Addendum #3 - April 21st, 2020

McLean County Highway Department

Section: 19-00073-11-BR

PIPE UNDERDRAINS 8"

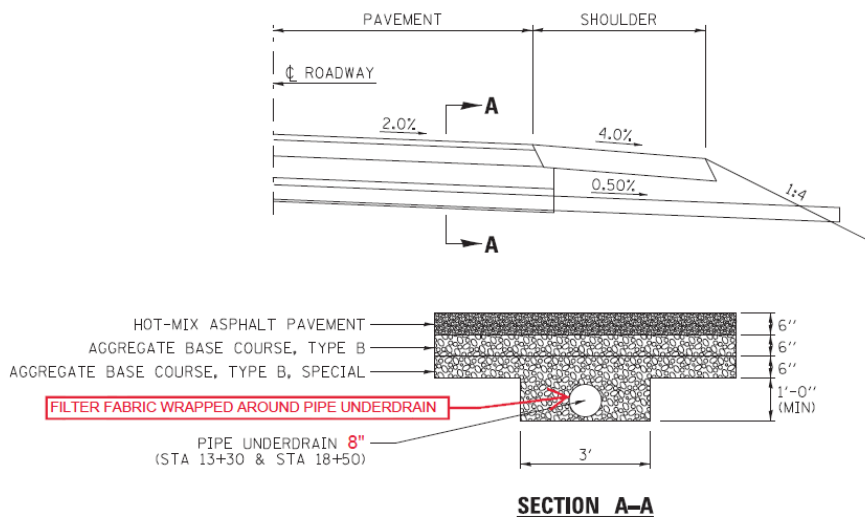
2. Revise the **PIPE UNDERDRAINS, 4"** detail to reflect **PIPE UNDERDRAINS, 8"** as shown below:

DETAIL SYMMETRICAL @ ϕ ROADWAY
